**ANCLOTE HARBOR APPLICATIONS
APPLICANT'S RESPONSES
To
BOARD OF COMMISSIONERS QUESTIONS**

I. RESPONSES TO QUESTIONS AT THE DECEMBER 8, 2020 BOARD OF COMMISSIONERS' HEARING

**ANCLOTE HARBOR APPLICATIONS
APPLICANT RESPONSE
To
BOARD OF COMMISSIONERS REQUEST
For
SECOND ACCESS VIA HAYS ROAD**

Exhibit 1 Secondary Access Exhibit

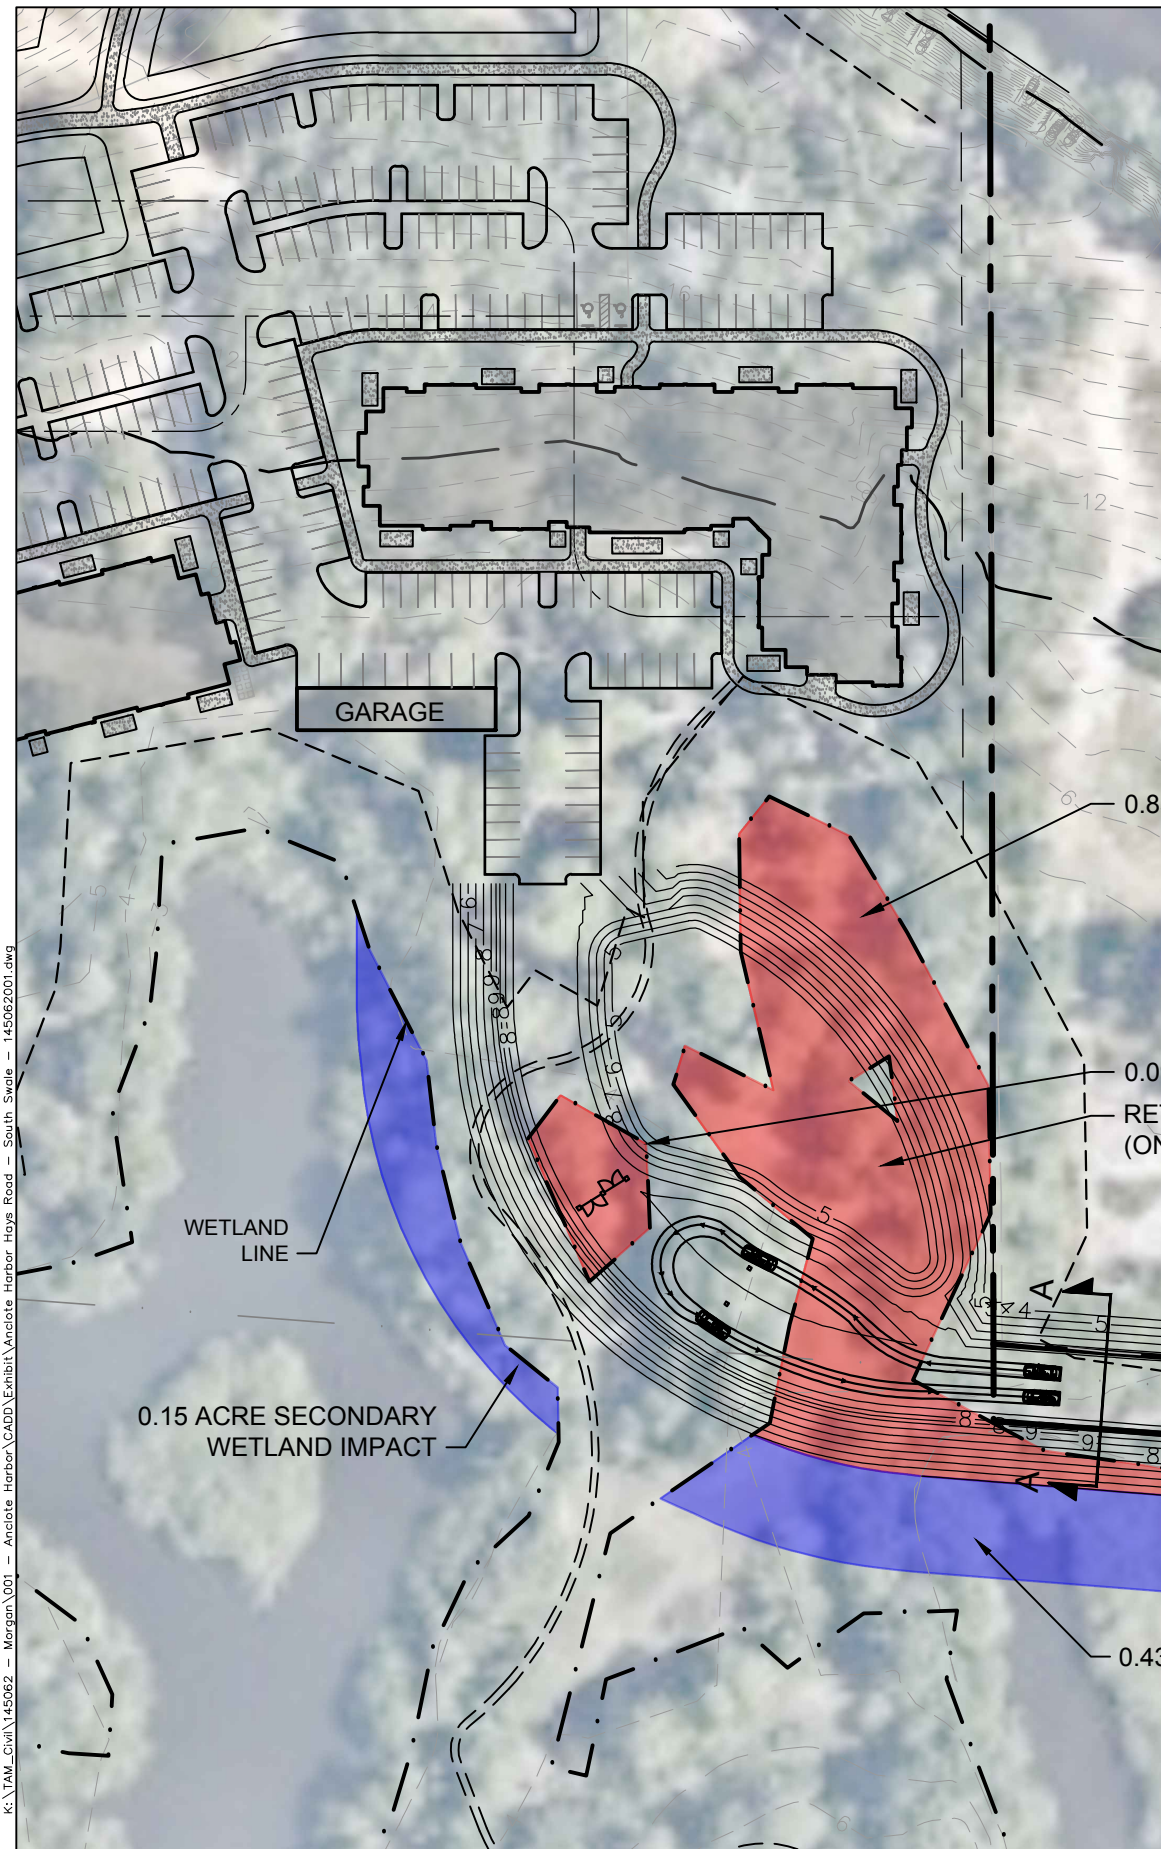
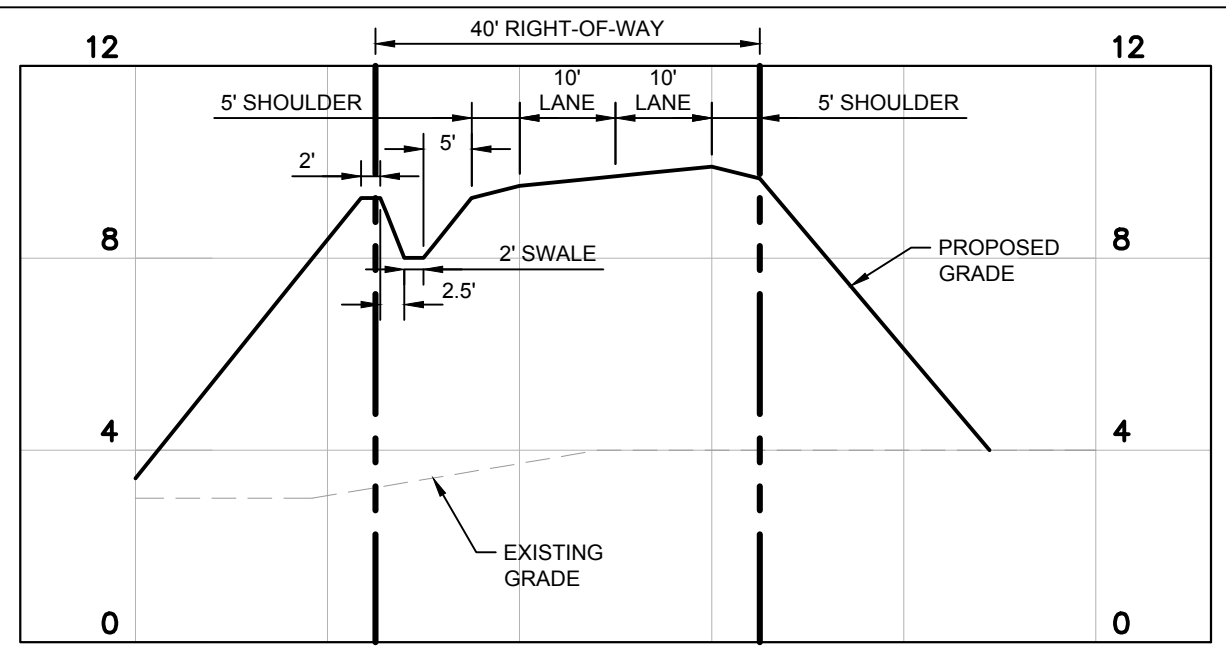
Since the last hearing, the Applicant evaluated the potential access to Hays Road in more detail and identified that additional wetlands within the project will be impacted due to the construction of the new driveway connection to Hays Road and the stormwater management area to serve the road. The new onsite wetland impacts are estimated as 1.52 acres in size, meaning that 1.52 acres of wetlands will have to be removed from their existing location and mitigated elsewhere on the site. Additionally, this wetland is under the jurisdiction of the Army Corps of Engineers (ACOE) and a permit will be required from this agency in order to remove the wetlands and mitigate for them. The ACOE permit is a lengthy process that can take one or more years to achieve, which time delay is expected to negatively affect the construction schedule by reducing the amount of time for construction outside of the eagle nesting season. The new connection to Hays Road will also reduce the size of the uplands nature preserve on the southeast peninsula. By avoiding impacts to the wetlands and the nature preserve, the waiver to not provide a second access meets a third waiver criteria of "Protection of Significant Features."

During the public hearings, the Applicant has heard the concerns of the Commissioners about their desire for a second access and has evaluated this road construction in detail. There are significant physical challenges to building this road that will make it impossible for the Applicant to build the road. Please refer to **Exhibit 1**, Secondary Access Exhibit, that illustrates the challenges involved in building a road within the existing right-of-way. Based on the information available to date, these challenges include the following issues:

- The existing Hays Road right-of-way is 40' in width, which is substantially less than the City's minimum 50' width for a local road.
- The construction of the road will require fill material and grading due to the difference between the elevation of the existing grade of 4' and the required grade for the road of 8'.

- The construction of the road including the fill material and grading will require grading on private property outside of the right-of-way. To make this work possible, the adjacent property owners will need to grant additional right-of-way and/ or easements for this work. Only a government, such as the City or Pinellas County, has the authority to obtain right-of-way and/ or easements from these property owners through their powers of eminent domain.

- Due to the narrow substandard right-of-way, there is not enough room to install a sidewalk on even one side of the road and also comply with the necessary grading.

- Based on aerial photographs, it appears that there are wetlands in the right-of-way that would be impacted by the road construction. The existing substandard right-of-way does not provide enough land area to mitigate for these wetland impacts.

- Like all development activity, the proposed road will require some method of stormwater management. The existing substandard right-of-way is not expected to be enough land area to build both the road and its stormwater management system.

In recognition and support of the City's interest in building the road and to assist the City in building the road, the Applicant proposes to make a major financial commitment that would provide the funds for the City to build this road. The estimated impact fees for the project are \$573,680 and the Applicant proposes to supplement those fees with a donation to the City of \$100,000 for a total of \$ 673,680 available for the road construction.

Utilizing FDOT Cost per Mile Estimating for an Undivided 2 Lane Rural Road, the Applicant's Engineer has estimated the construction cost for Hays Road to be \$ 509,000, excluding the cost of right-of-way and/ or easements. Therefore, the project's transportation impact fees and the Applicant's donation combined together are \$ 673,680, which exceeds the \$ 509,000 estimated cost of constructing Hays Road. If the City is in agreement with this proposal and builds the road, the Applicant will connect the project to the Hays Road right-of-way and revise the site plan accordingly.

“Should the City elect to build Hays Road, the Applicant will connect the project to new Hays Road, pay transportation impact fees estimated at \$573,680, and will contribute an additional \$100,000 to the City to defray the City’s cost of construction of Hays Road east to Jasmine Avenue. The City agrees to notify the Applicant in writing of its decision to build, or not build, Hays Road within 90 days of Final Development Plan approval.”
